Access Compliance Report

Public Rights-of-Way

(Curb Ramps)

Intersection ID: 10027438	Main Street: GOODMAN_PARK_CT	Cross Street: N/A	Location: SE
ADA ID: 628211D746E4	Ramp Type: Perp	Initial Pass/Fail: Fail	Overall Compliance: No
Severity Score: 10			
Codes/Mitigation Info/Possible Solution		Field Measurements/Component Compliance

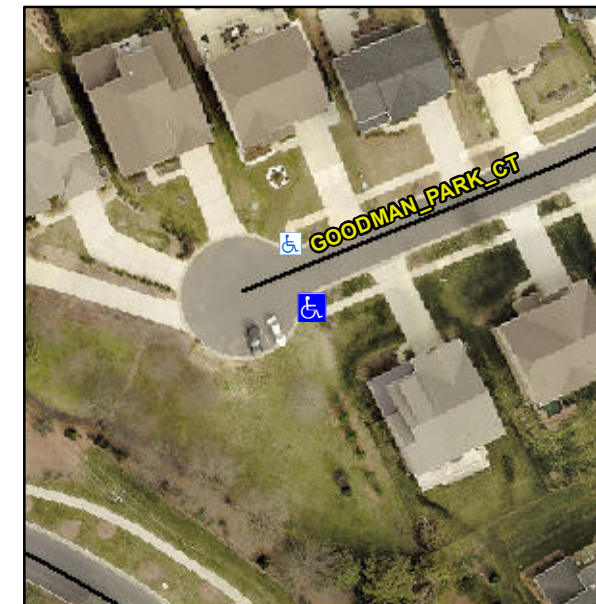
Not Found, R304.5.1, R304.5.3

Compliance	Description	Data	Compliance	Description	Data
N/A	Ramp Length (in)	93.0	Yes	Ramp Slope (%)	7.6
No	Ramp Width (in)	47.0	No	Ramp XSlope (%)	2.8
N/A	Flare Type LT	N/A	N/A	Flare Type RT	N/A
N/A	Flare Slope LT (%)	N/A	N/A	Flare Slope RT (%)	N/A
N/A	Flare Traversable LT?	N/A	N/A	Flare Traversable RT?	N/A
N/A	Landing Length (in)	N/A	N/A	DWS Provided?	N/A
N/A	Landing Width (in)	N/A	N/A	DWS Contrast?	N/A
N/A	Landing Slope (%)	N/A	N/A	DWS Length (in)	N/A
N/A	Landing X Slope (%)	N/A	N/A	DWS Full Width?	N/A
N/A	Landing Curb? (Y/N)	N/A	N/A	DWS Offset (in)	N/A
N/A	Shared Landing?	N/A			
N/A	Gutter Ponding?	N/A	N/A	Gutter Slope (%)	N/A
N/A	Gutter Lip Ht (in)	N/A	N/A	Gutter X Slope (%)	N/A
N/A	Painted X Walk1?	No	N/A	Painted X Walk2?	N/A
	X Walk 1 Direction	To NW		X Walk 2 Direction	N/A
N/A	X Walk 1 Width (in)	N/A	N/A	X Walk 2 Width (in)	N/A
	X Walk 1 Slope (%)	3.2		X Walk 2 Slope (%)	N/A
	X Walk 1 X Slope (%)	1.1		X Walk 2 X Slope (%)	N/A

Remove & Replace Entire Ramp.
